UNITED STATES PATENT AND TRADEMARK OFFICE

APPLICATION NO.	FILING DATE	FIRST NAMED INVENTOR	ATTORNEY DOCKET NO.	CONFIRMATION NO.
10/825,407	04/14/2004	Keiji Ito	10873.1428US01	9378
7590	11/13/2006		EXAMINER	
Hamre, Schumann, Mueller & Larson, P.C. P.O. Box 2902-0902 Minneapolis, MN 55402			GOLUB, MARCIA A.	
			ART UNIT	PAPER NUMBER
			2828

Office Action Summary

DETAILED ACTION

Regarding **claim 1**, Fig 1 of '222 discloses a semiconductor laser device, comprising:

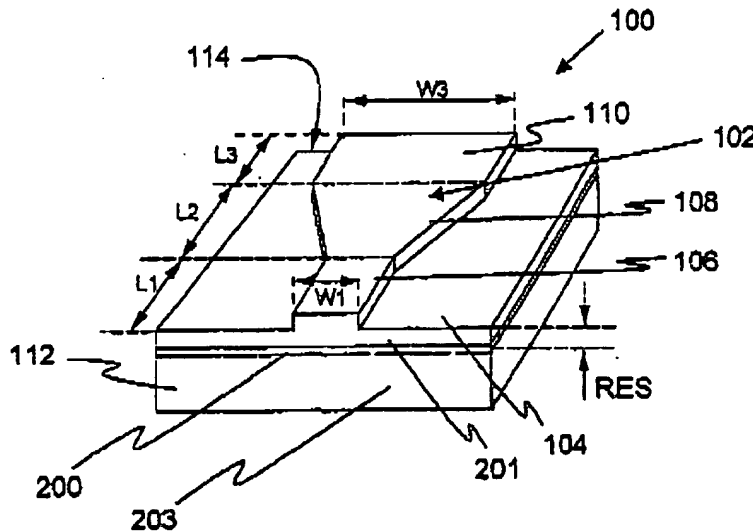
"a first conductivity type cladding layer [203]; an active layer [200]; and a second conductivity type cladding layer [201], which are on a substrate [204],

wherein the semiconductor laser device further comprises a stripe structure [102] for injecting carriers therein,

a width of the stripe is wider at a front end face [W3] of a resonator [100] from which laser light is emitted than at a rear end face [W1] that is located on an opposite side of the front end face, (paragraph 0062)

and a reflectance of the front end face [114] is lower than a reflectance of the rear end face [112]; (paragraph 0062)

a ratio between the stripe width [W3] at the front end face and the stripe width at the rear end face [W1] satisfies a relationship of $1 < (\text{the stripe width at the front end face}) / (\text{the stripe width at the rear end face}) < 2$ (for example: $W3=9$, $W1=5$ um, $W3/W1=1.8$, paragraph 0023);

the stripe structure has regions adjacent to the front end face [W3,L3] and the rear end face [W1,L1], the regions respectively extending inwardly from the front end face [114] and the rear end face [112] and each having a constant stripe width;

the region having the constant stripe widths on the front end face side has a length of one-twentieth or shorter of a length of the resonator ($L1 < L/20$) [$L1 < 16L/20$],

and the region having the constant stripe width on the rear face side has a length of one-twentieth or shorter of a length of the resonator ($L3 < L/20$) [$L3 > L/25$].” (paragraphs 0024, 0026)

‘222 does not disclose that the stripe width at the rear end face is between 1.4 and 2.0 μm . ‘222 discloses the stripe width [W1] to be between 3 and 5 μm . However, the optimization of range is not inventive unless it is accompanied by unexpected results, see MPEP 2144.05. It would have been obvious to one of ordinary skill in the art at the time of the invention to make the stripe width at the rear end face between 1.4 and 2.0 μm , since it has been held to be within the general skill of a worker in the art to discover the optimum or workable ranges by routine experimentation.
